ADDENDUM NUMBER 1
TO THE DRAWINGS AND SPECIFICATIONS

PROJECT: Washington Street Gym HVAC Improvements

FOR: Macomb CUSD No. 185
323 W. Washington Street
Macomb, IL 61455

A/E PROJECT NO: 2547 0220

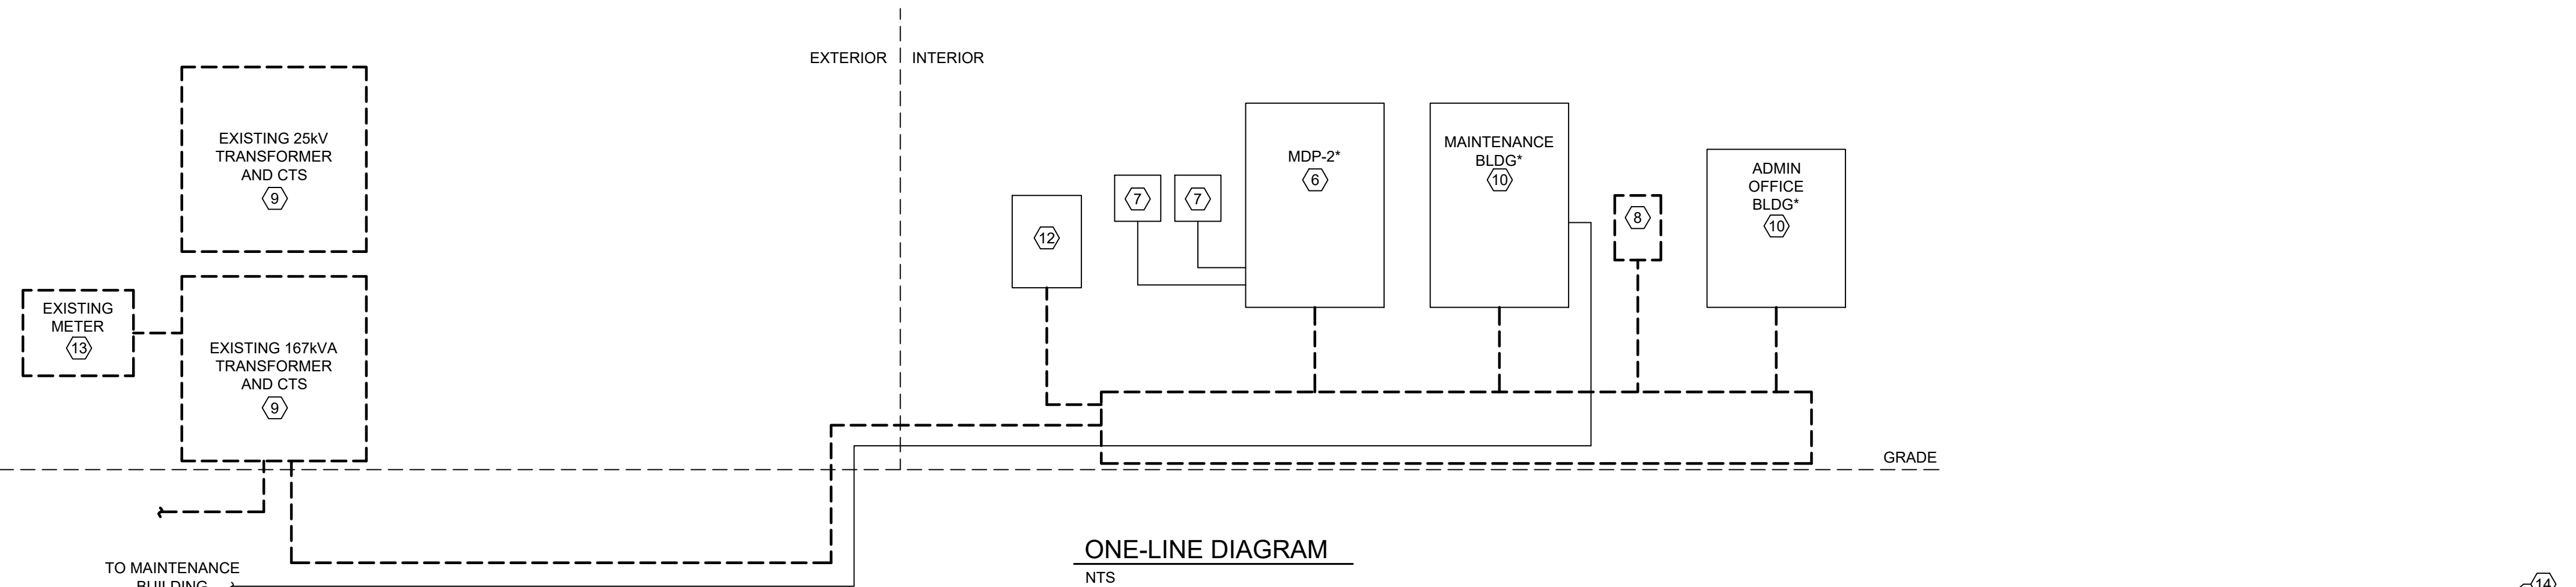
1. TO THE SPECIFICATIONS; Section 23 0700, and The Drawings: Thermaduct on exterior of building, surfaces that show to view shall be painted to match building. Paint system for PVC surface shall be as recommended by paint manufacturer including a bonding primer and two (2) coats of acrylic vinyl paint. Provide additional coats as needed for uniform coverage and color match.
2. TO THE DRAWINGS; Equipment area at Northeast corner along Washington Street, see attached revised drawing
 - a. Remove brick planter box, patch and repair intersecting exposed surface as needed.

- b. Regrade surface, slope up uniformly to slab following adjacent ramp.
- c. Bury short offset 4" PVC downspout line.

- d. Adjust fence layout shown on revised drawing. Fence will require sleeves or coring concrete.
 - e. Extend slab 6" beyond fence on east edge.
 - f. Provide 12" x 6" minimum drop apron along slab east edge to grade up to.
3. TO THE DRAWINGS; Sheet M101, Note 16, two locations: Provide wire guard over controls and thermostats.
 4. TO THE DRAWINGS; See attached revised with revisions in bubbles, Sheet D101 and M101

DESIGNED SFD	DRAWN APW
FIELD	FIELD BOOK
CHECKED SFD	CHECK DATE 07/29/2022
SHEET TITLE MECHANICAL & ELECTRICAL DEMOLITION PLAN	
PROJECT NO. 21-0155	
DRAWING ISSUED DATE: 08/01/2022	
SHEET D101

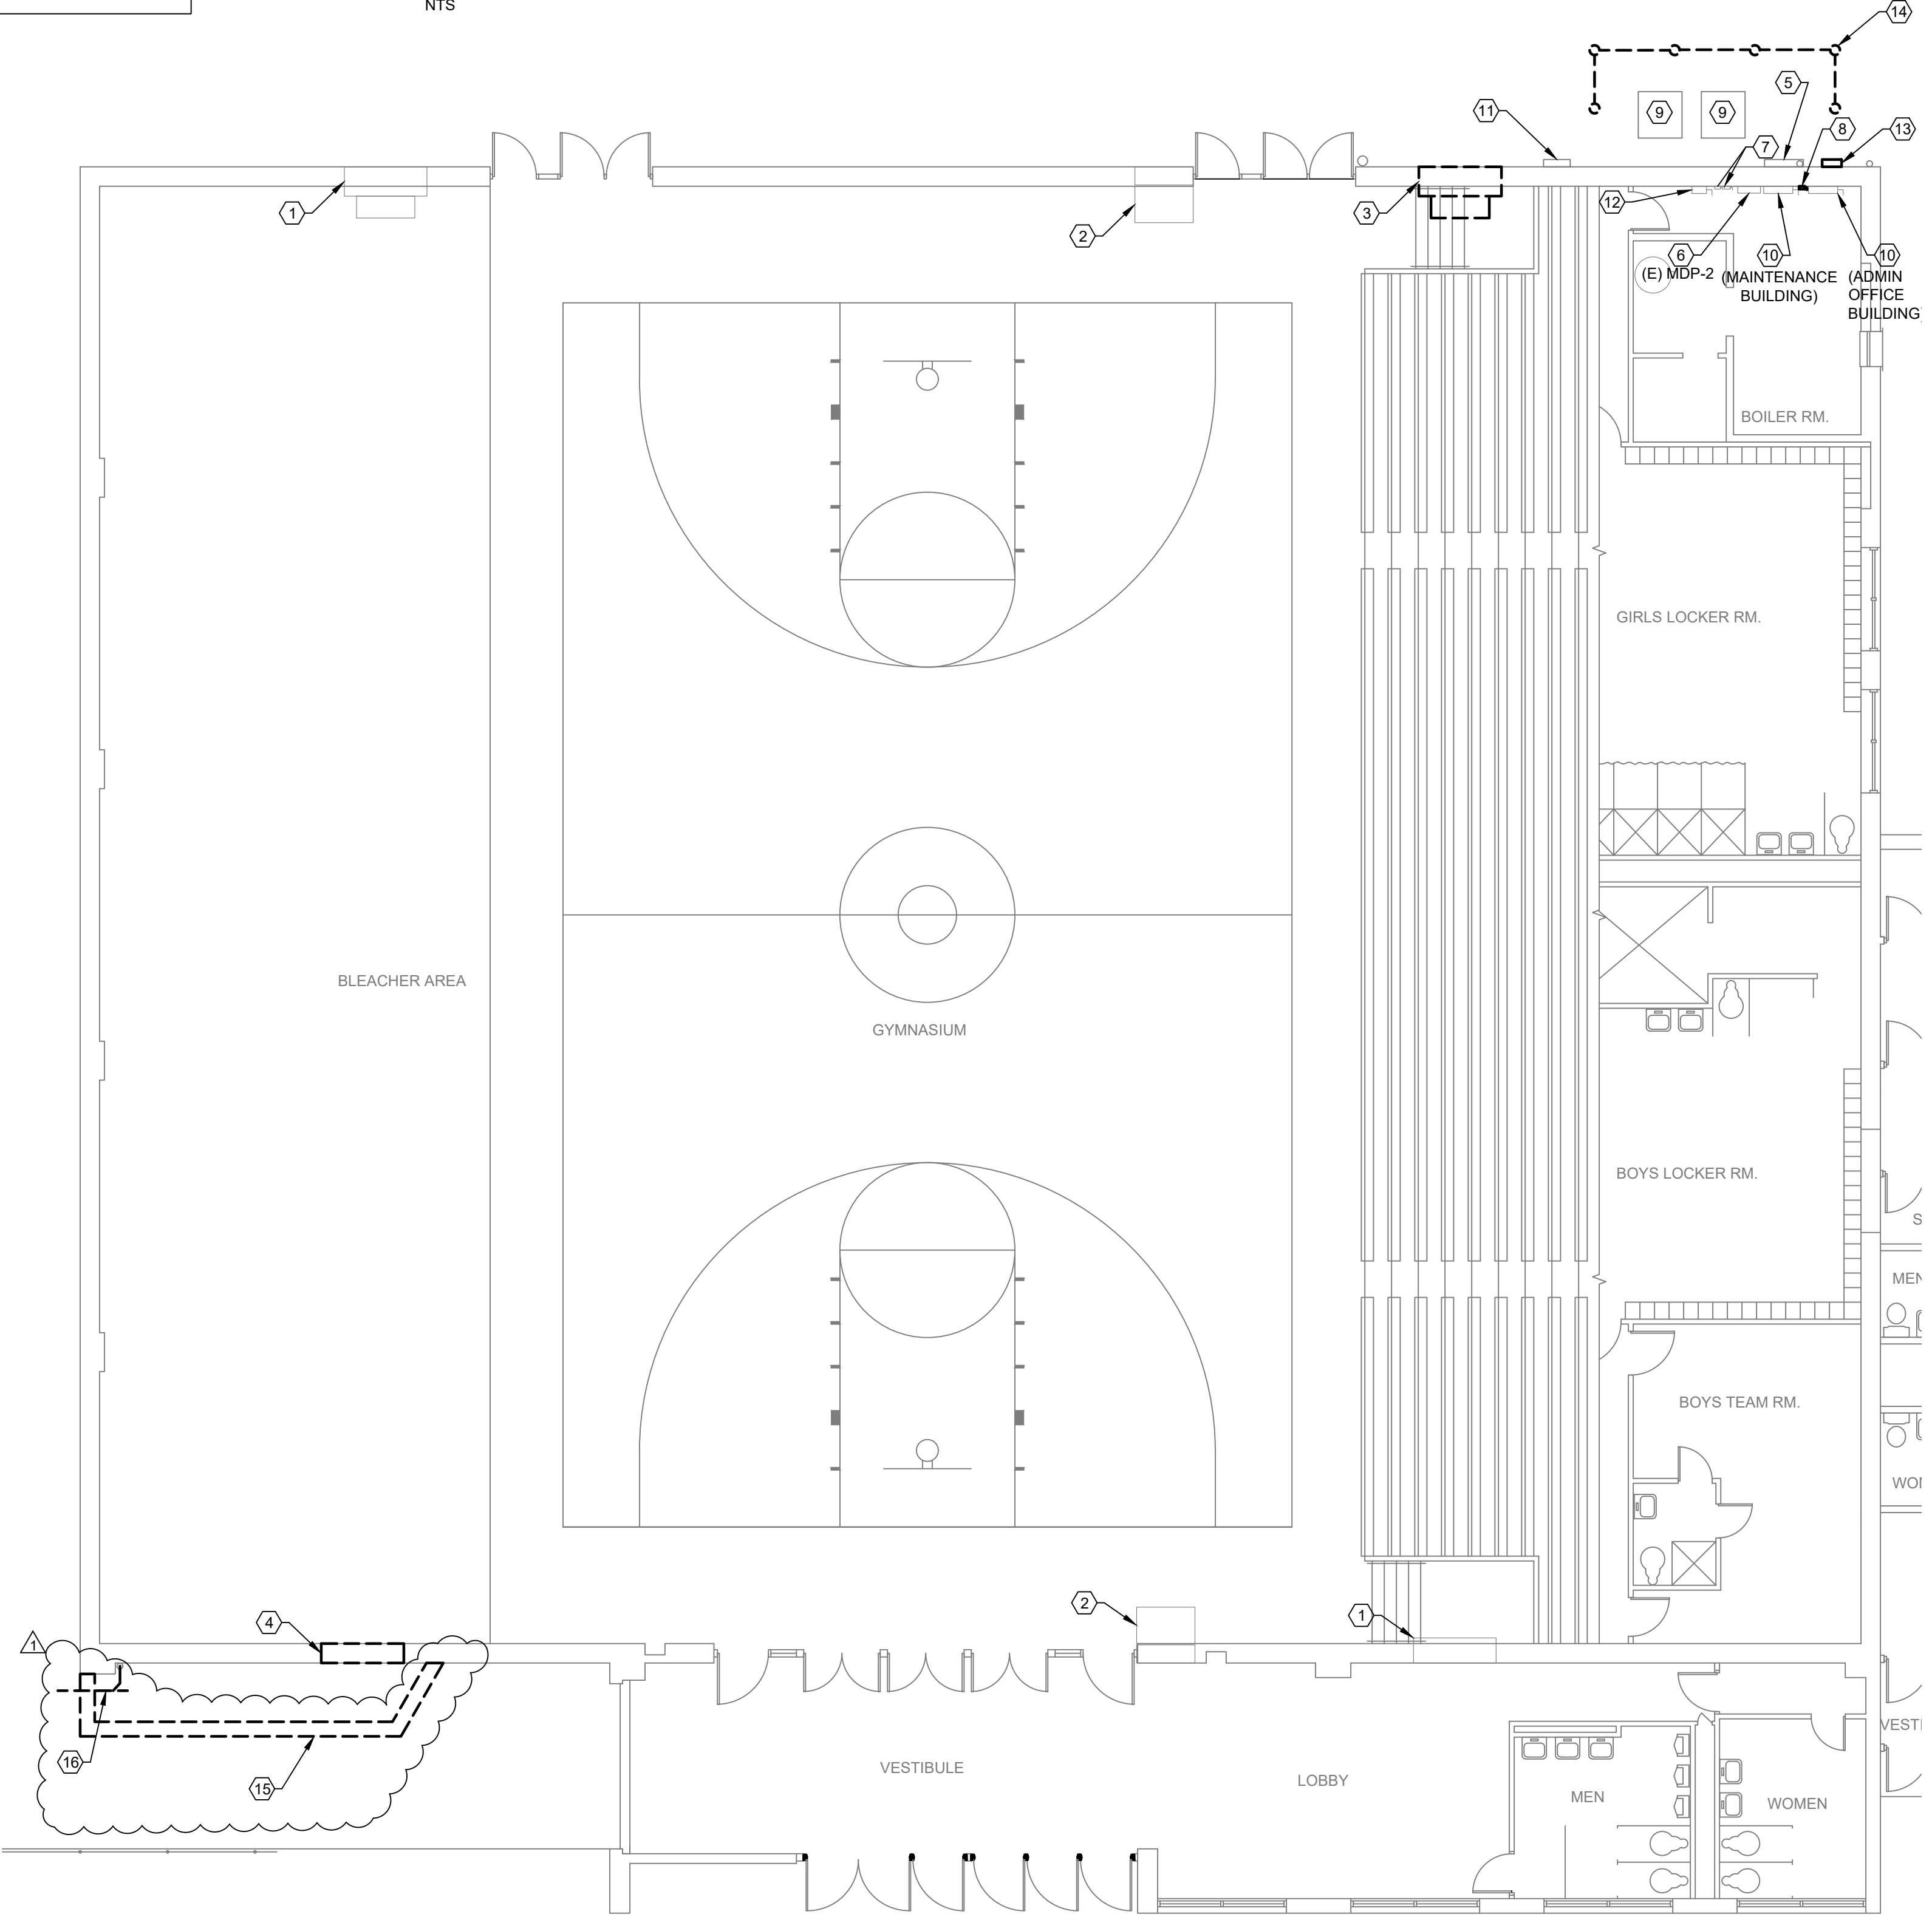
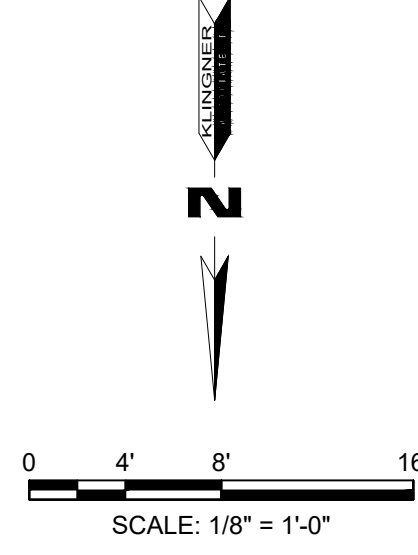
- 15 REMOVE PLANTER RETAINING WALL IN ITS ENTIRETY. SAWCUT BRICK WHERE IT INTERSECTS EXISTING BUILDING TO MAKE FLUSH WITH EXISTING WALL. TUCKPOINT AS REQUIRED.

- 16 REMOVE PORTION OF STORM PIPING TO ALLOW FOR REMOVAL OF PLANTER RETAINING WALL. SEE RENO PLAN.

SHEET TITLE
MECHANICAL PLAN
PROJECT NO.
21-0155
DRAWING ISSUED DATE:
08/01/2022
SHEET
M101

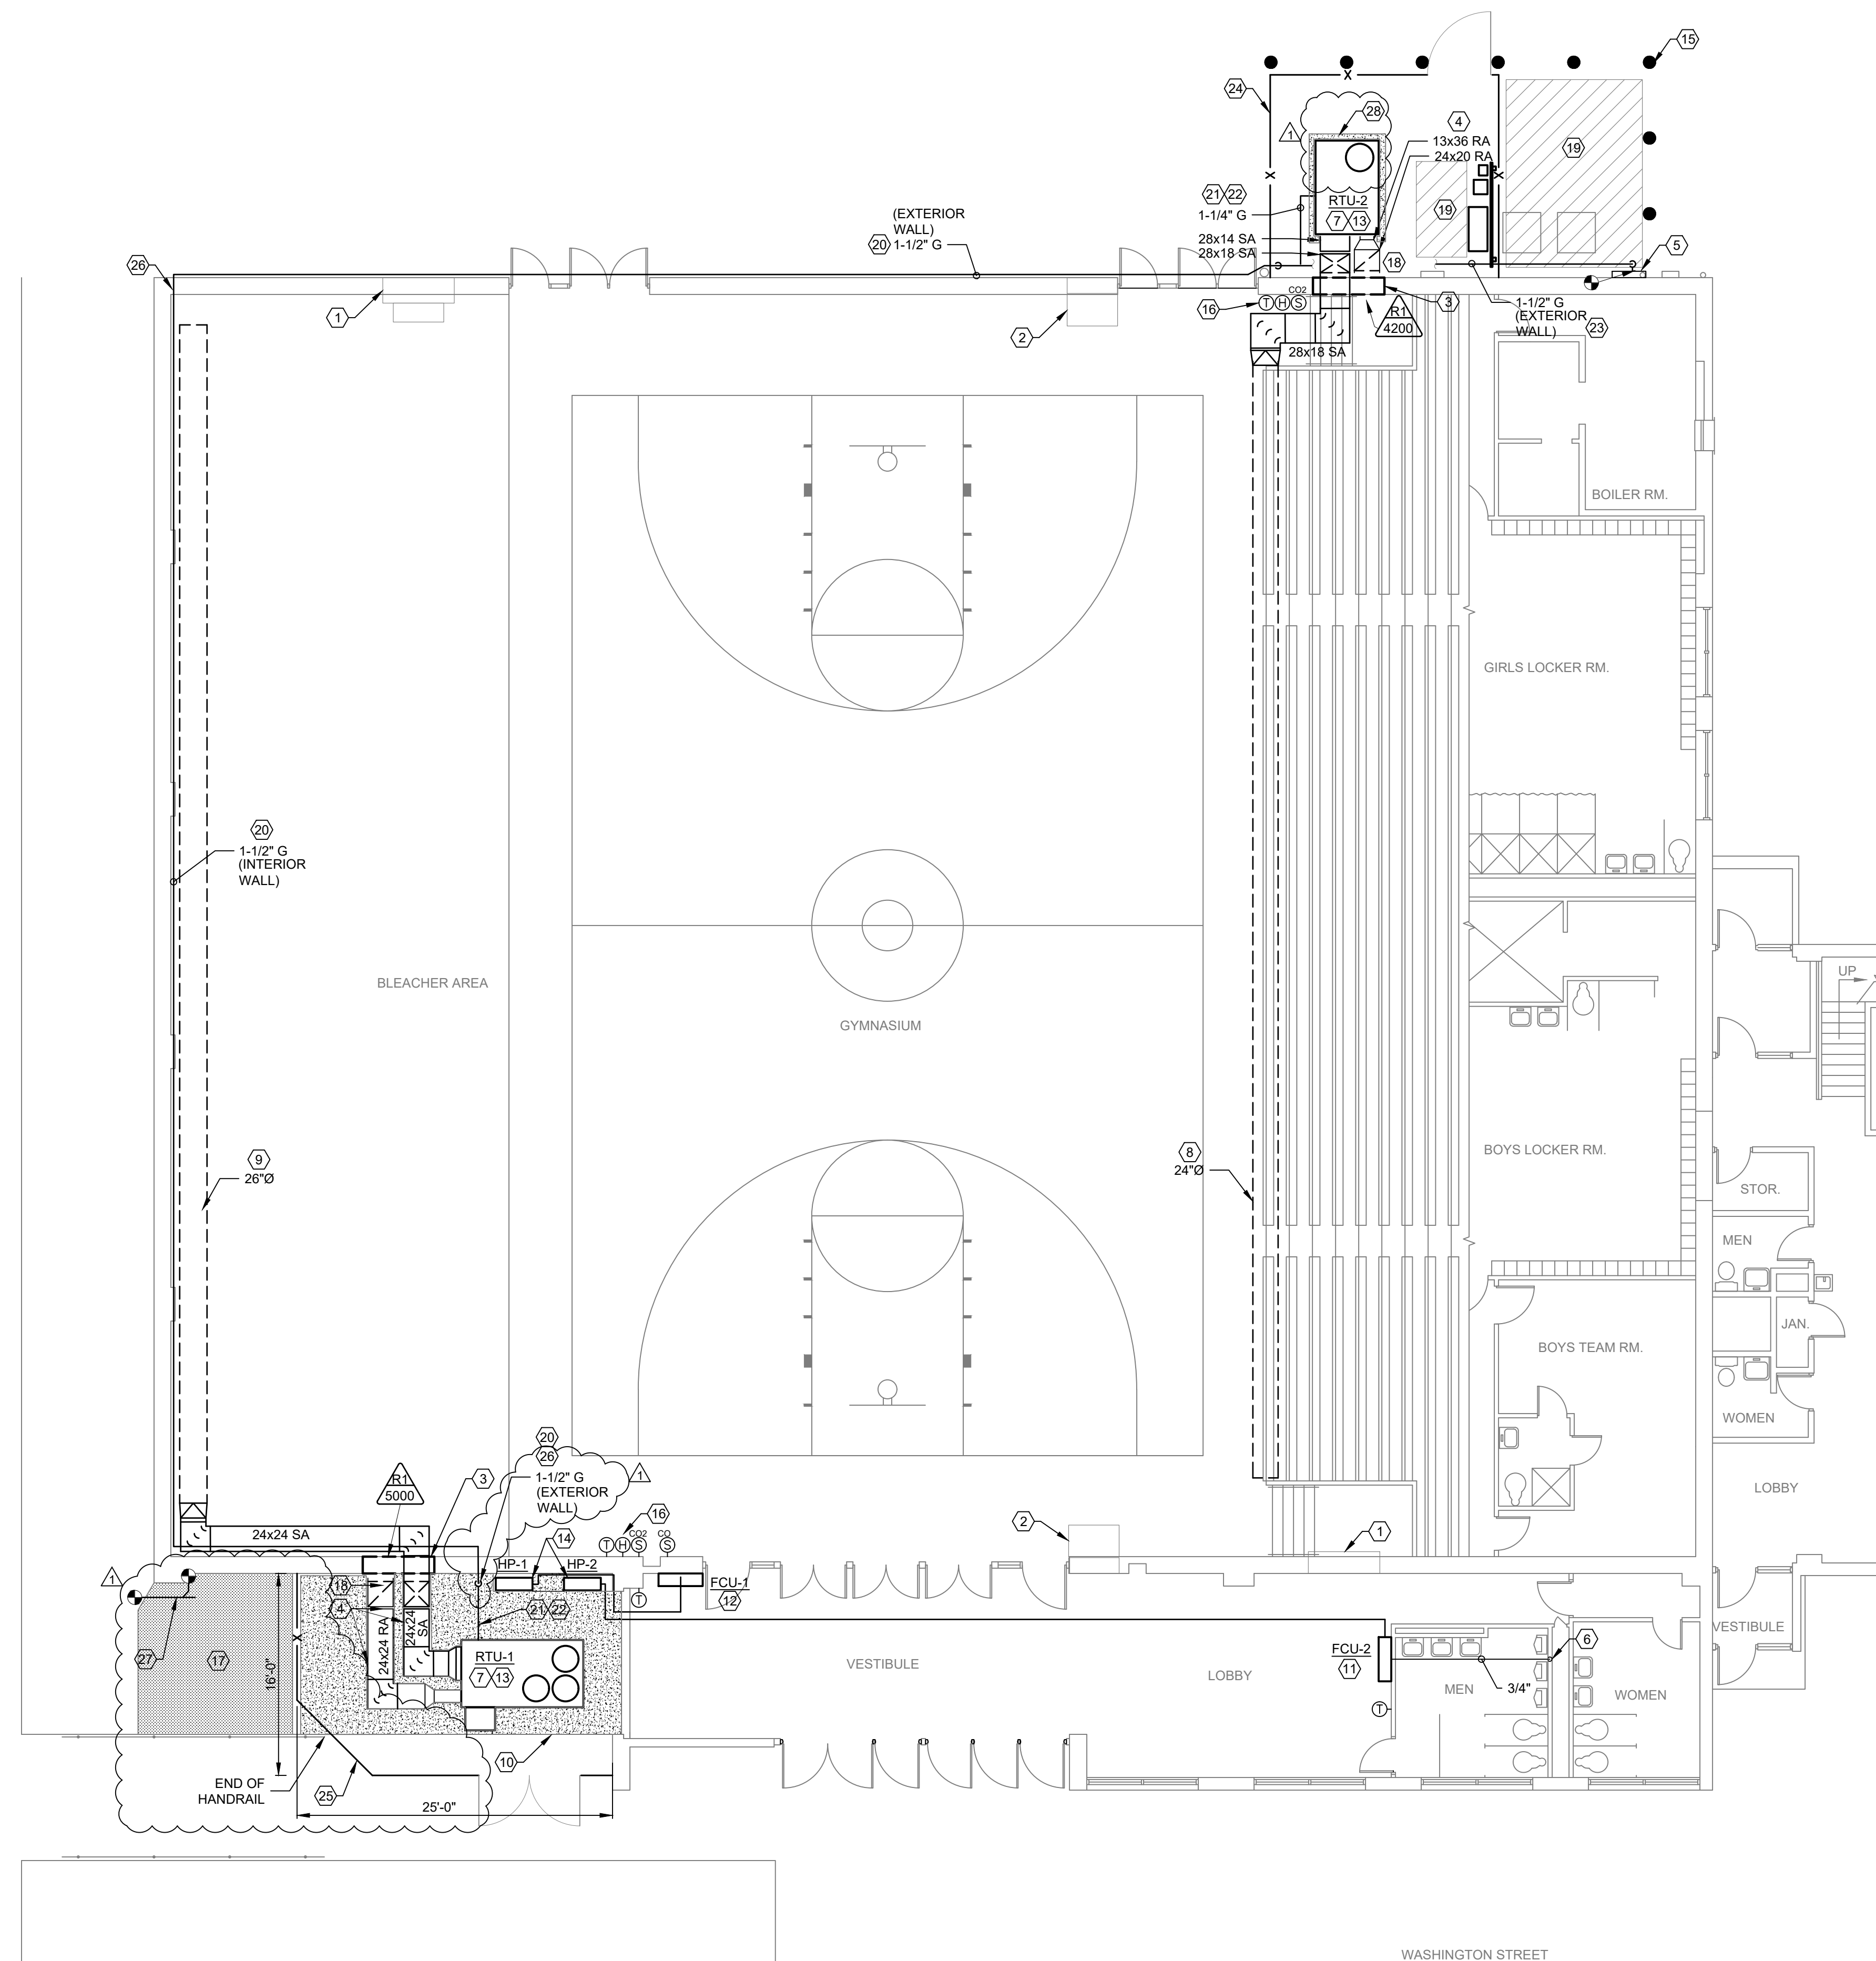
16. PROVIDE NEW SENSORS LOCATED ON EXTERIOR WALL ON AN INSULATED BASE. PROVIDE PROTECTIVE COVER FOR NEW THERMOSTATS.
17. RE-GRADE AND SEED TOPSOIL WHERE GRADE HAS BEEN DISTURBED.
